**Recirculated Final Environmental Impact Report
for the**

**SMUD Solano Wind Project
Phase 3**

February 2010

CHAPTER 2
RESPONSE TO COMMENTS

Figure 4.10-1
Solano County General Plan
Land Use Designations

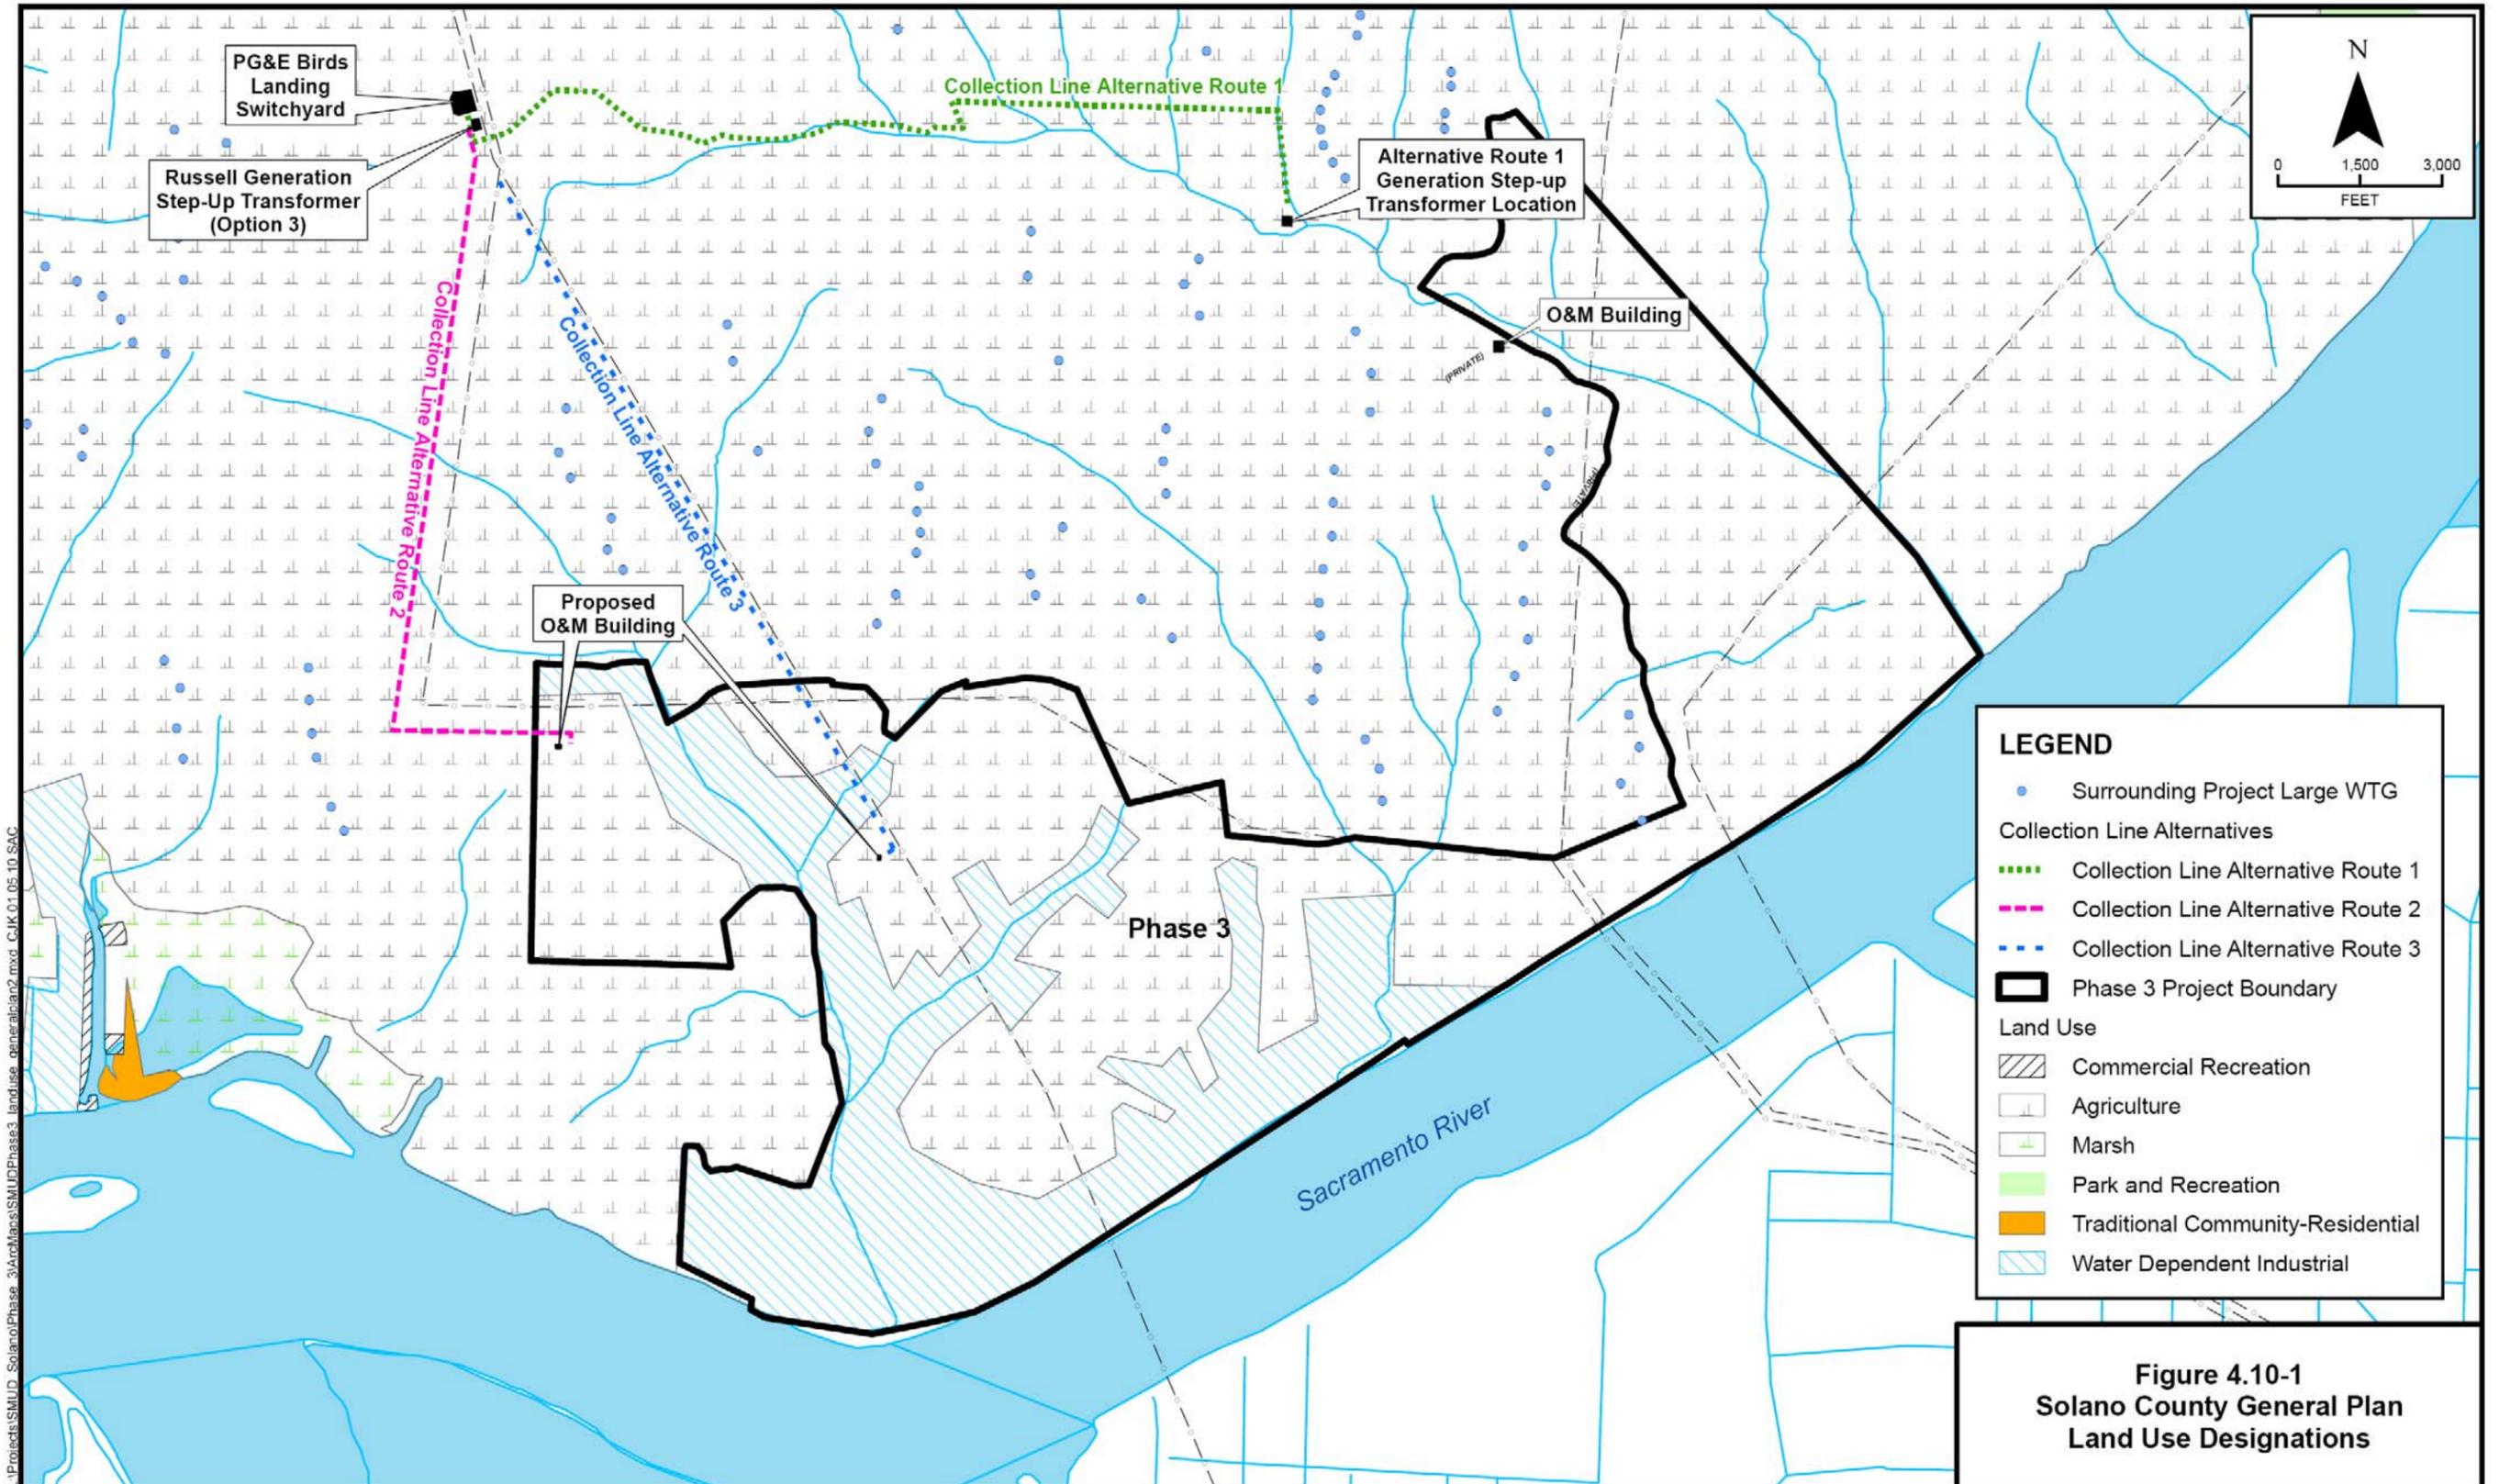
<p>22. Page 4.10-2 & 4.10-5 – General Plan, Zoning Ordinance, and Wind Turbine Siting Plan:</p> <p>a) Section 4.10.1.2 including Figure 4.10-1 incorrectly state that the land use designation for a portion of the subject property is "Extensive Agriculture." The correct designation is "Agricultural." The distinction between Intensive and Extensive Agricultural lands was eliminated with the 2008 General Plan. Also, to be clear, I-WD, which is referenced in this section as a General Plan designation is a zoning classification only; the name of the corresponding General Plan designation is Water Dependent Industrial (not I-WD).</p>	<p>C-20 Mitigation BIO-5b incorporates into text the following:</p>
<p>b) The referenced zoning classification for the property is incorrect. The property is zoned Exclusive Agricultural, A-160, not I-WD, except possibly for one parcel (APN 0090-180-050), which was previously identified as part of the project area according to Table 2-1 in the FEIR, but otherwise appears outside the current project boundaries identified in the RDEIR. Most of the project that was zoned I-WD comprised the 411 acres that was removed in accordance with the revised project description.</p>	<p>C-20a An explanation as to how the range of 68 to 107 acres of mitigation land was derived to enable independent verification of the stated range of potential mitigation acreages has been added as a third paragraph of Mitigation BIO-5b, as follows:</p>

Comment	Response
	<p>RFEIR, and no further changes to the EIR are required.</p> <p>C-22a SMUD agrees that the predominant land use designation for the project area is “Agriculture.” However, a 1,300-acre parcel owned by Greenport Energy Park LLC within the project boundary is designated as Water Dependent Industrial (I-WD) in the 2008 General Plan. The zoning classification for all project lands is “Exclusive Agriculture” (A-160). No project lands are currently zoned I-WD. Section 4.10.1.2, paragraphs 2 and 4, have been revised as follows:</p> <p style="padding-left: 40px;">The Solano County General Plan identifies goals, policies, and implementation measures to guide the development and conservation of natural resources within the county on a long-term basis. The General Plan designates the project area as Extensive Agriculture and I-WD Water Dependent Industrial. The intent of the Extensive Agriculture designation is to protect productive agricultural land from the intrusion of non-agricultural development. The purpose of the I-WD Water Dependent Industrial designation is to accommodate industrial development along the Sacramento River as provided for in the Collinsville-Montezuma Hills Area Plan.</p> <p>And:</p> <p style="padding-left: 40px;">The Solano County Zoning Ordinance designates a 1,300-acre portion of the project area as being a I-WD District classifies the entire project area as “Exclusive Agriculture” (A-160) including a 1,300-acre parcel owned by Greenport Energy Park LLC. Wind energy development is a consistent use with the “Exclusive Agriculture” zoning classification. An adjacent 411-acre parcel owned by SMUD, but not included in the project, is currently zoned I-WD. The purpose of this district is to reserve waterfront lands for large-scale, water-dependent industries to ensure an that there is efficient use of waterfront industrial sites.</p> <p>Figure 4.10-1 has been revised accordingly.</p> <p>The commenter does not identify any new impact or mitigation for the project, and no further change to the EIR is required.</p>
